ADDENDUM NO. 2

**Three Rivers Community Schools – Three Rivers Middle School Additions and
Renovation**

SHEET CLARIFICATIONS / REVISIONS

2
M8.03 AHU-23.1 CONTROL DIAGRAM
NOT TO SCALE

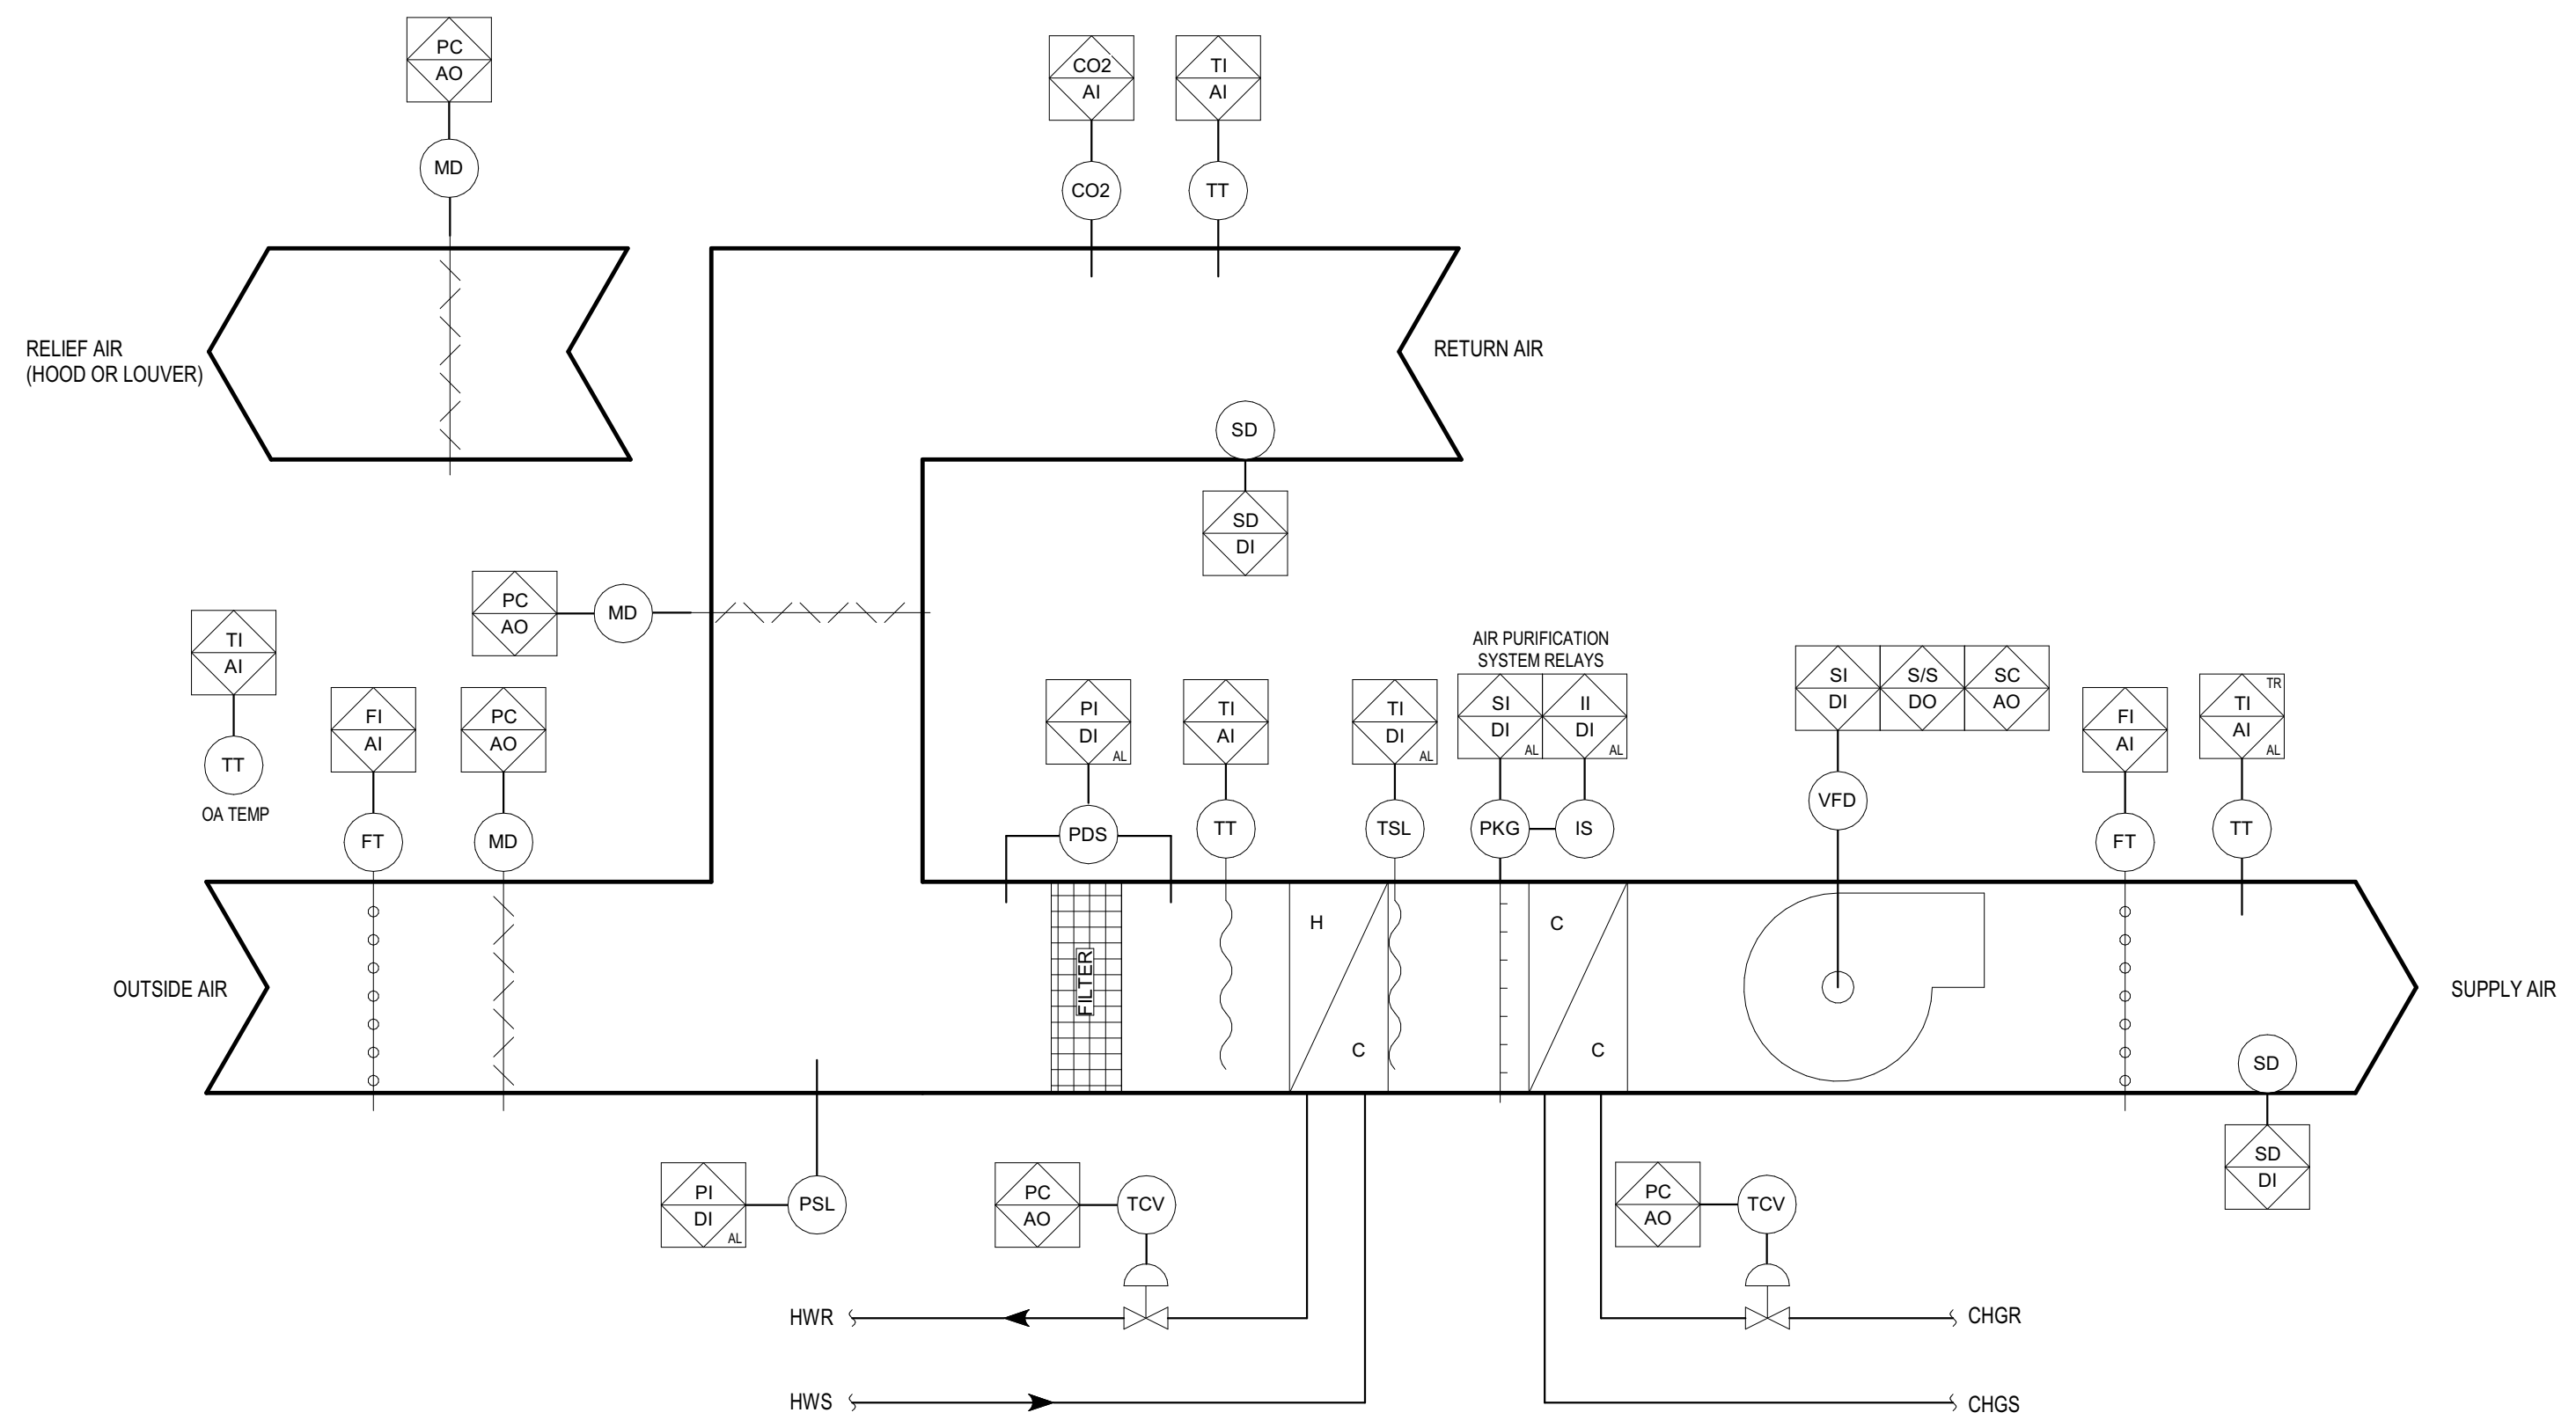
ITEM NO. 50 SHEET M8.03 MECHANICAL CONTROL DIAGRAMS (REISSUED)

Revised Mechanical Control Diagrams 2 and 3.

UNIT 'E' FIRST FLOOR ELECTRICAL DEMOLITION PLAN
1/8" = 1'-0"

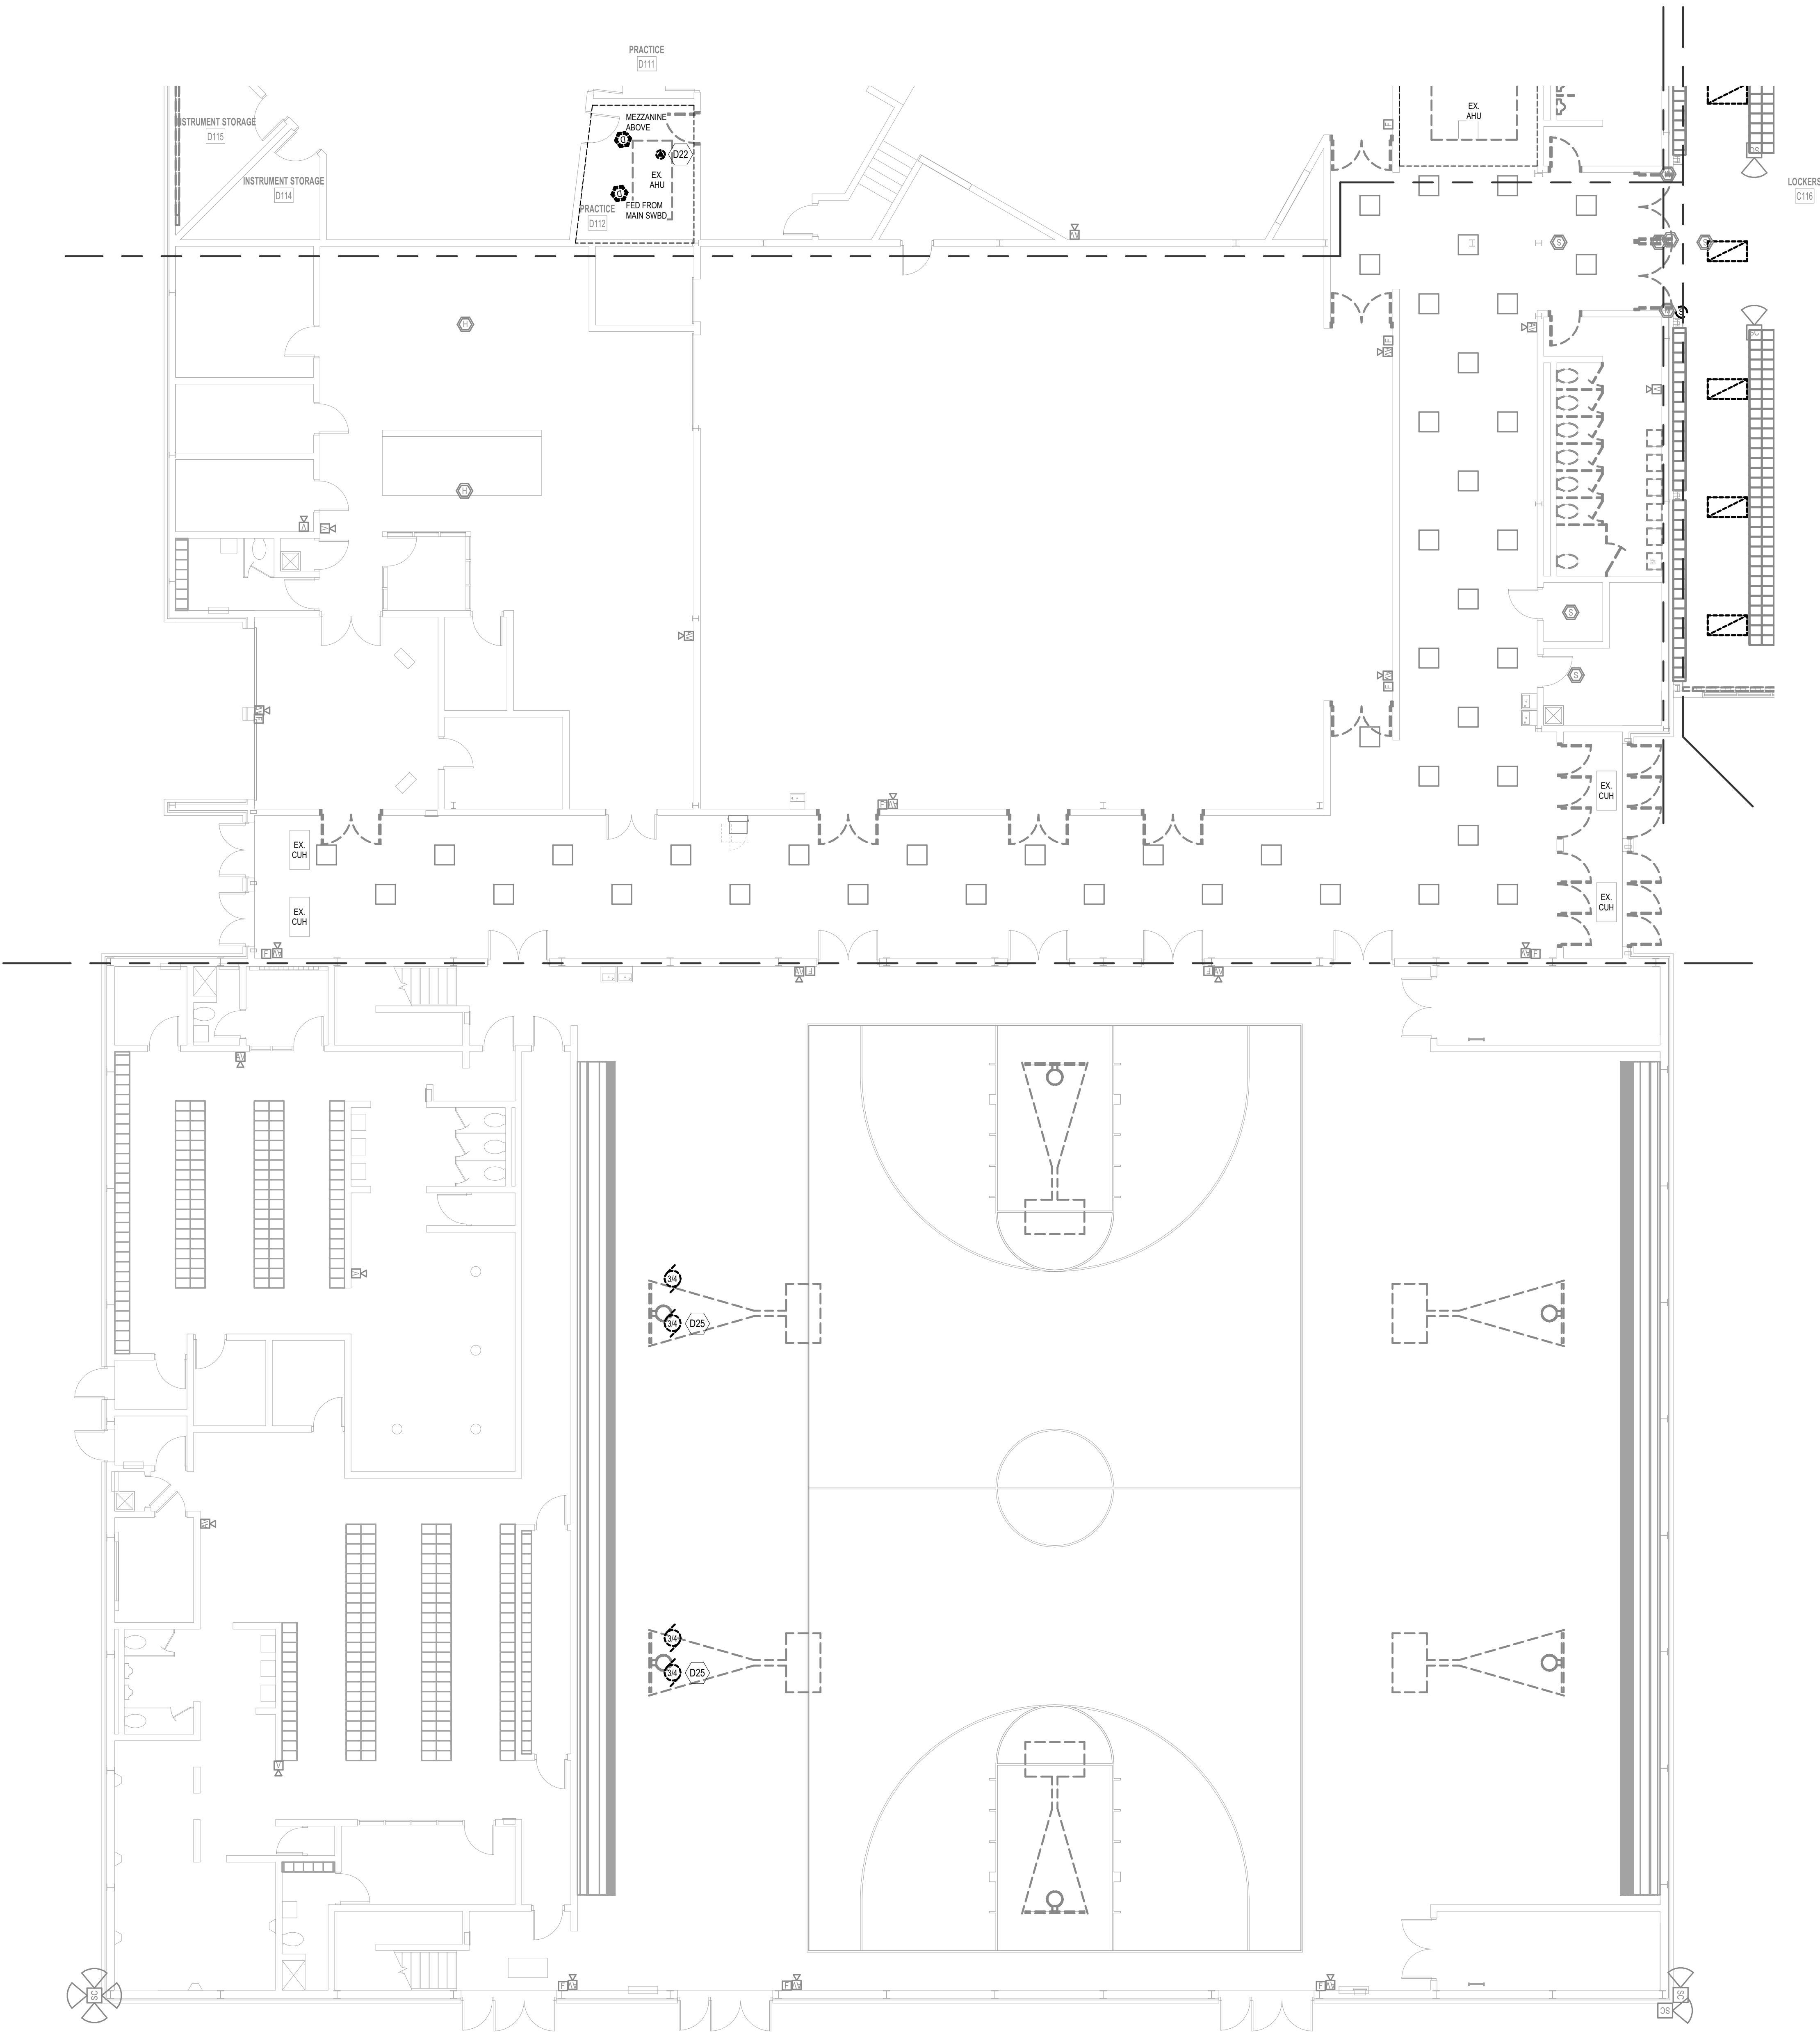
ITEM NO. 54 SHEET E1.1E UNIT 'E' FIRST FLOOR ELECTRICAL DEMOLITION PLAN (NEW)

Refer to the plan for the (4) added notes for the disconnect and reconnect of (2) basketball motorized backboards.

UNIT 'B' FIRST FLOOR POWER & COMMUNICATIONS PLAN
1/8" = 1'-0"

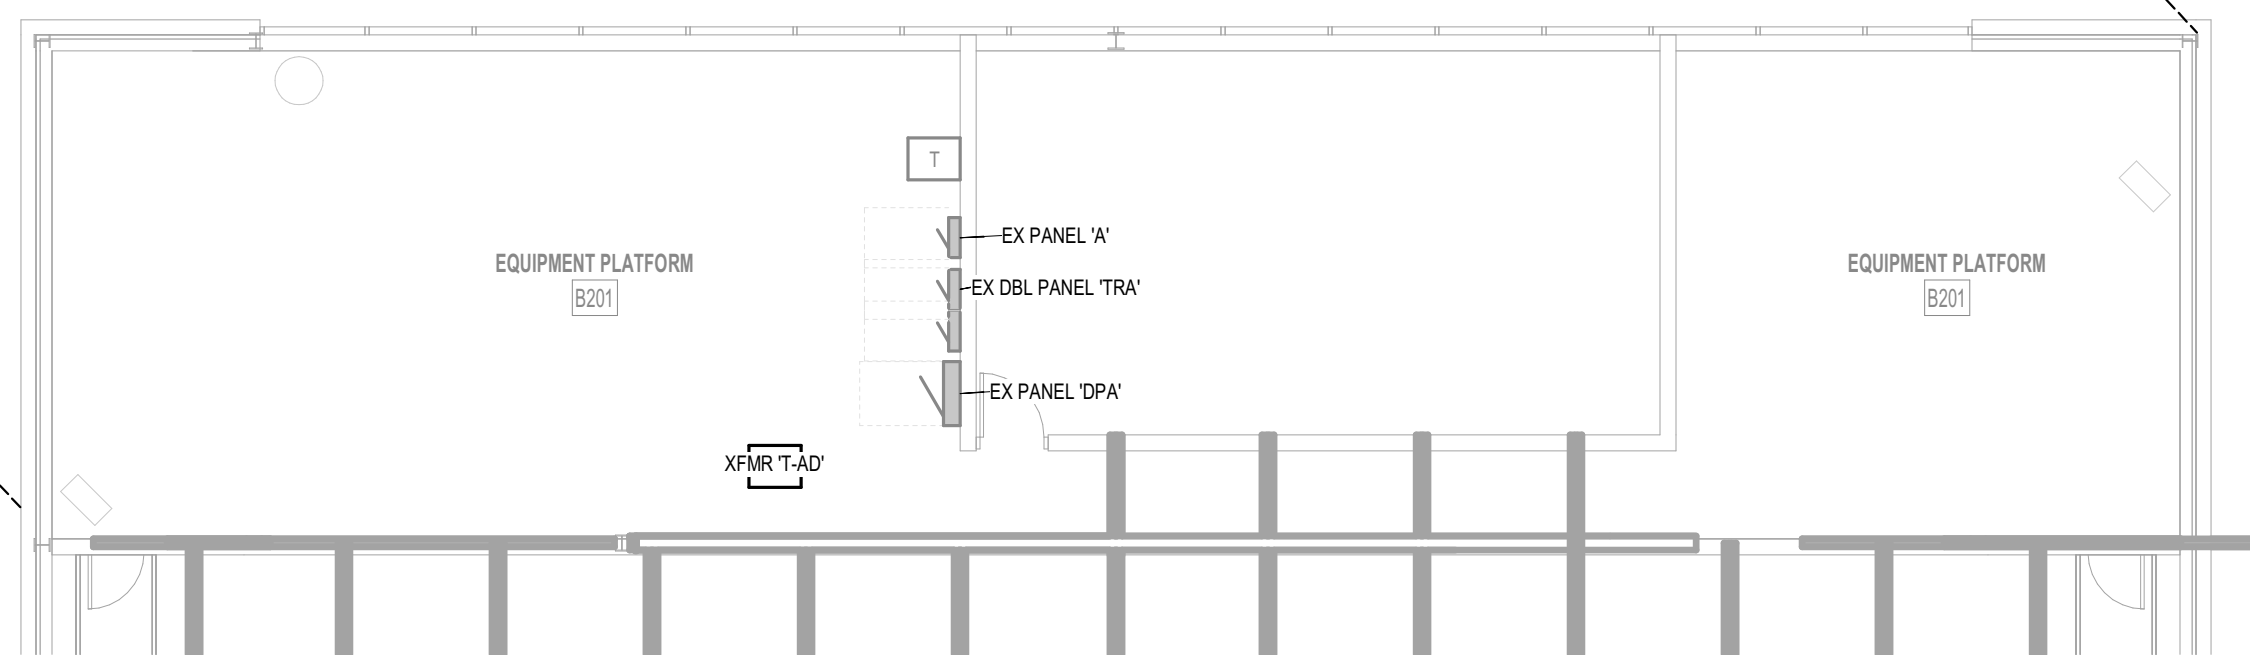
ITEM NO. 56 SHEET E2.1B UNIT 'B' POWER & COMMUNICATIONS PLAN (REISSUED)

Refer to the plan for the removal of FCU-22.
